## STONEHENGE, AVEBURY AND ASSOCIATED SITES

### United Kingdom (373bis)

In accordance with Decision **45 COM 7B.62** of the World Heritage Committee, the United Kingdom State Party has produced a State of Conservation Report for the Stonehenge, Avebury and Associated Sites World Heritage Site.

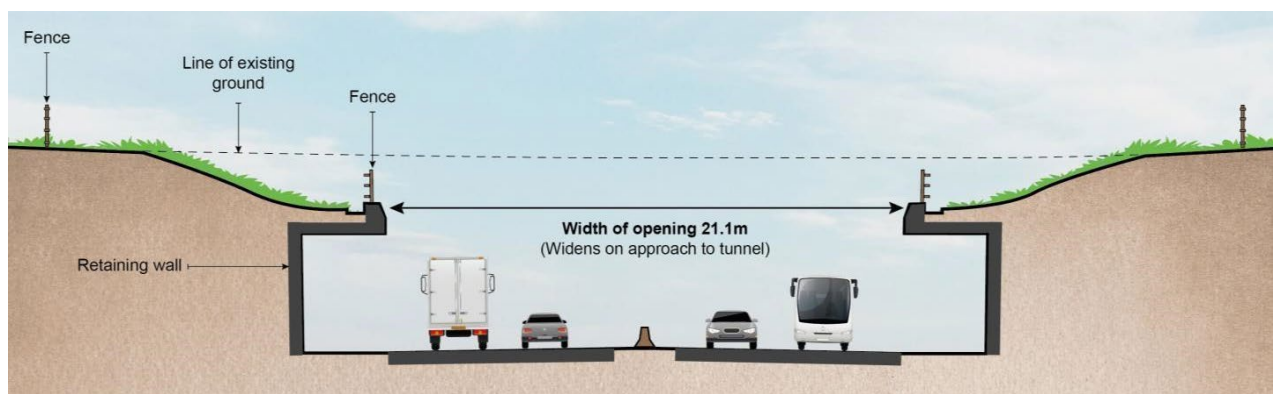
- 5.1. The current proposed width of the opening at the western approach is 28.1 metres.  
See cross-section:

- 5.2. In order to reduce the exposed western approach section, the proposal is for Cantilevers to extend 3.5 metres from each side of the retaining wall, for the full 850 metre length. This is the maximum cantilever extension possible within the proposed structure.
- 5.3. This would see the boundary fence moved to the edge of the cantilever, with the grass covering extended close to the edge of the opening and the width of the opening reduced to 21.1 metres.

- 5.4. This addition would reduce the cutting width by 25% and substantially improve the transition between the landscape and the road by reducing the sight and sound of the road. In particular, it would reduce visibility of the retaining wall when viewed from the north or south of the cutting.

MAINLINE LONGITUDINAL SECTION - CH 6700 TO CH 8200

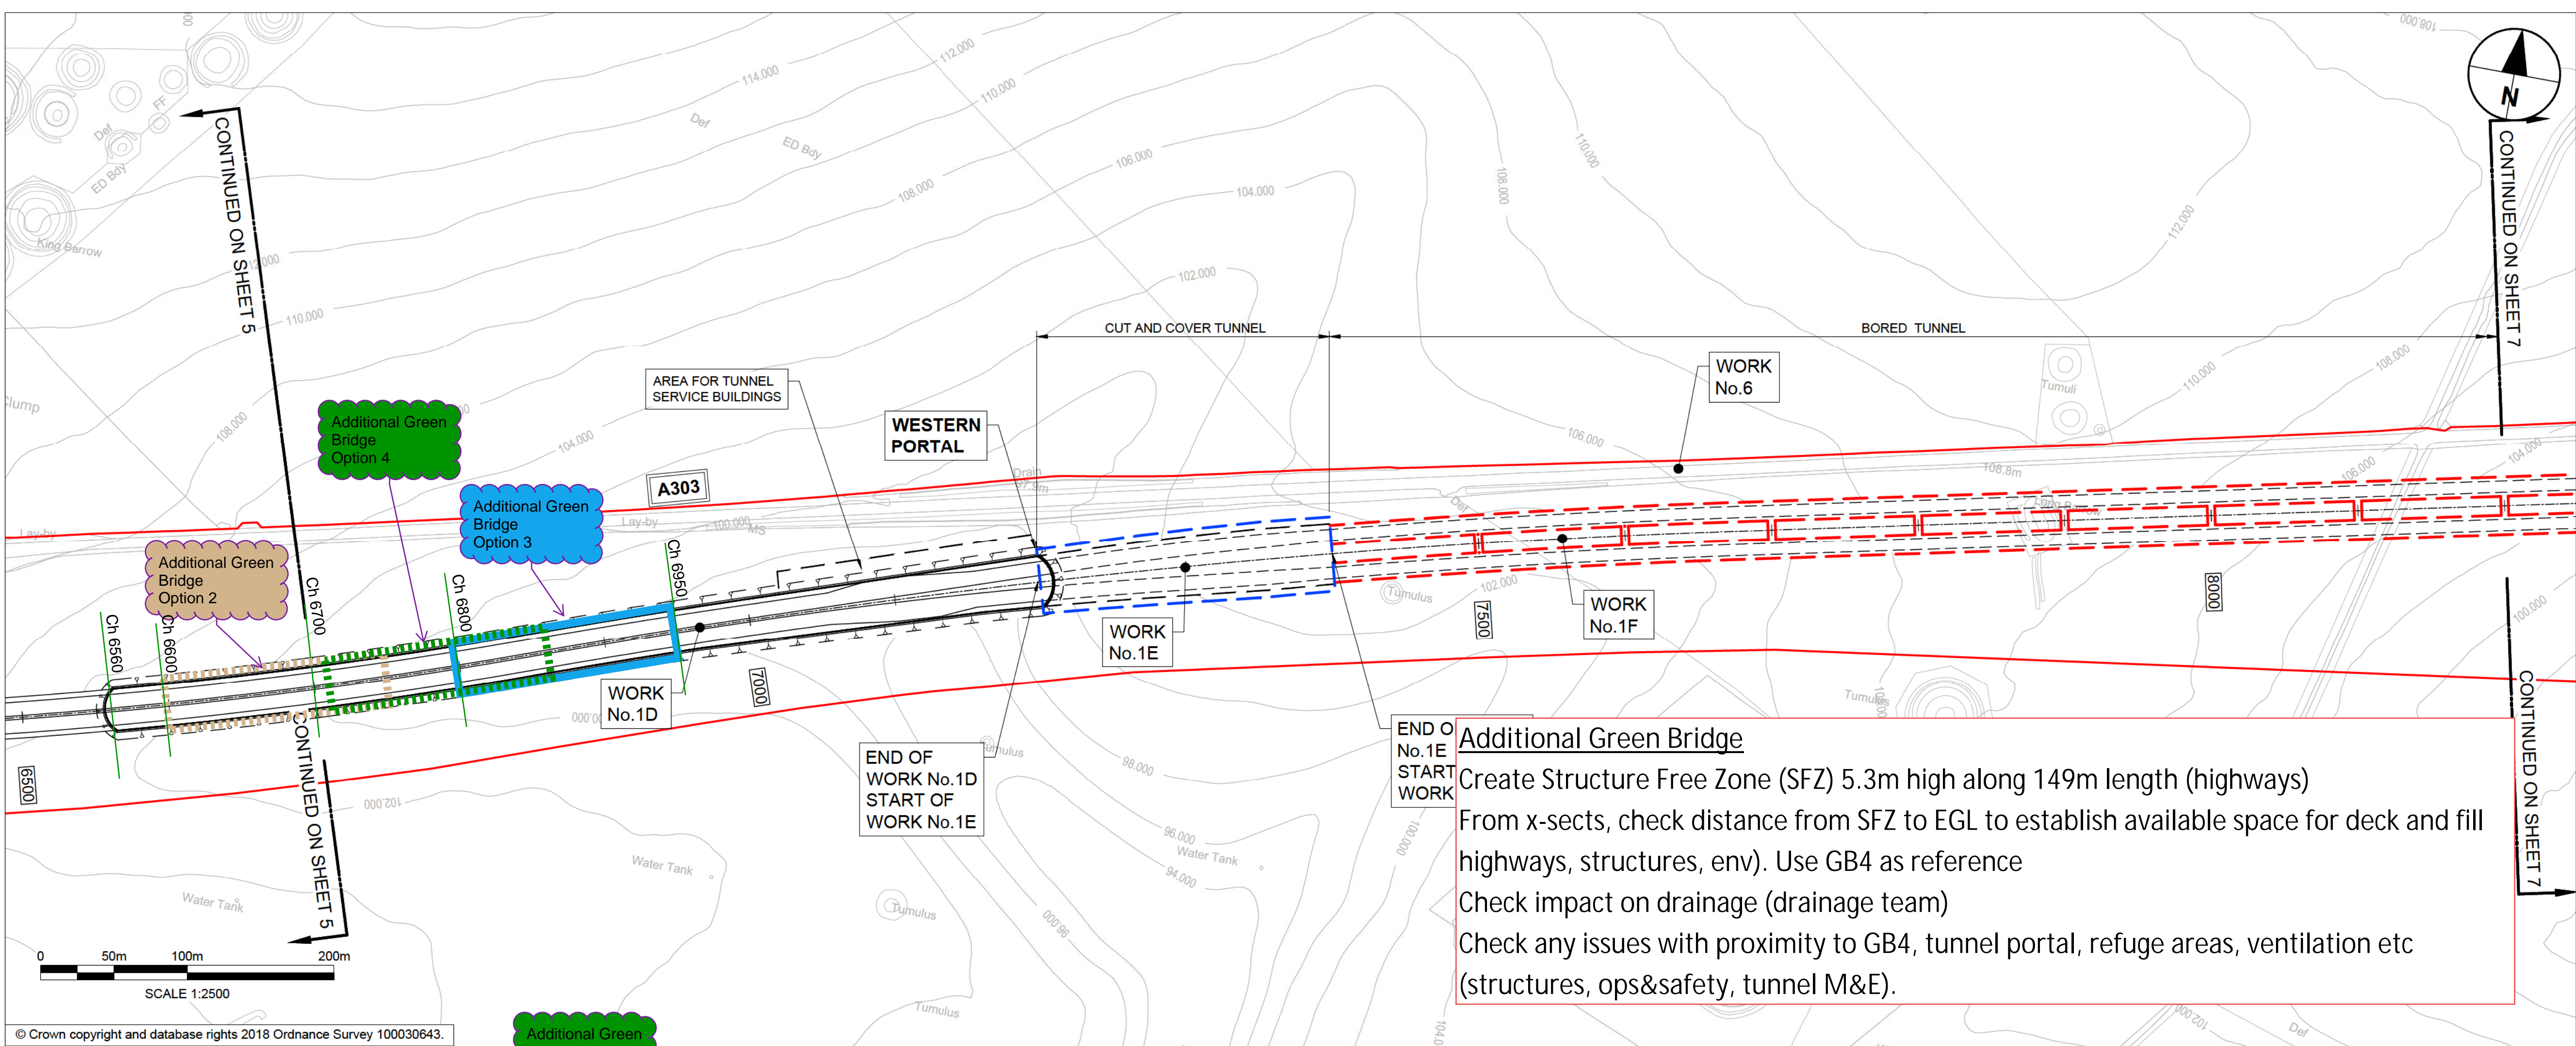
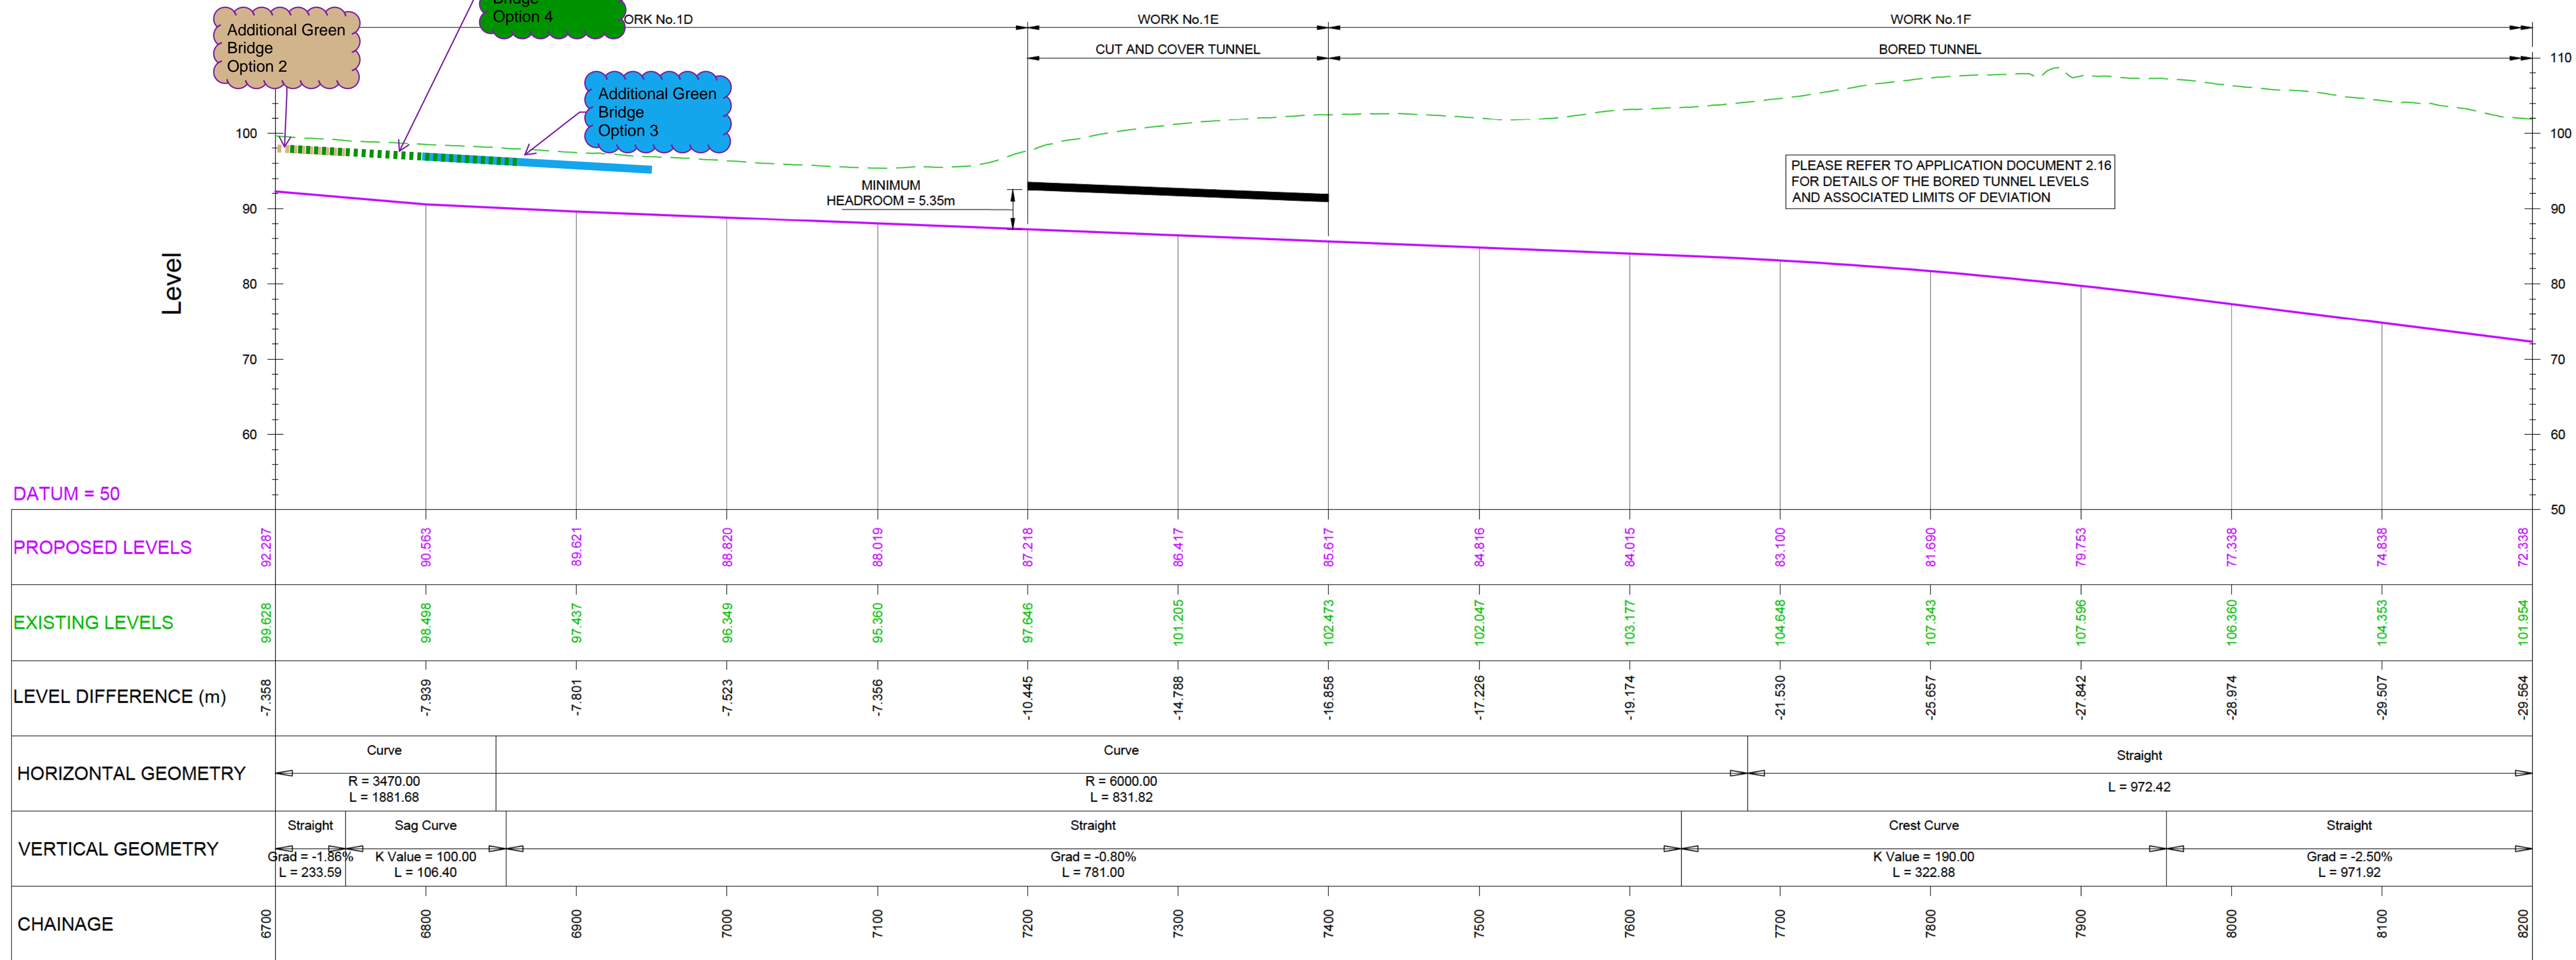
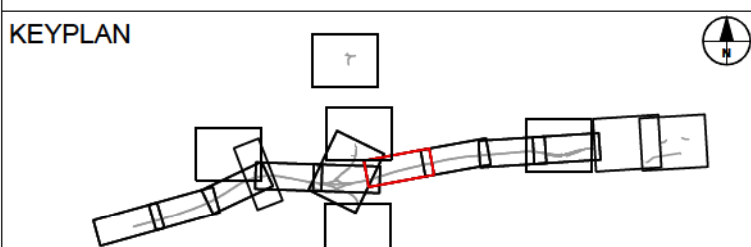
**Additional Green Bridge**  
Create Structure Free Zone (SFZ) 5.3m high along 149m length (highways)  
From x-sections, check distance from SFZ to EGL to establish available space for deck and fill (highways, structures, env). Use GB4 as reference  
Check impact on drainage (drainage team)  
Check any issues with proximity to GB4, tunnel portal, refuge areas, ventilation etc (structures, ops&safety, tunnel M&E).
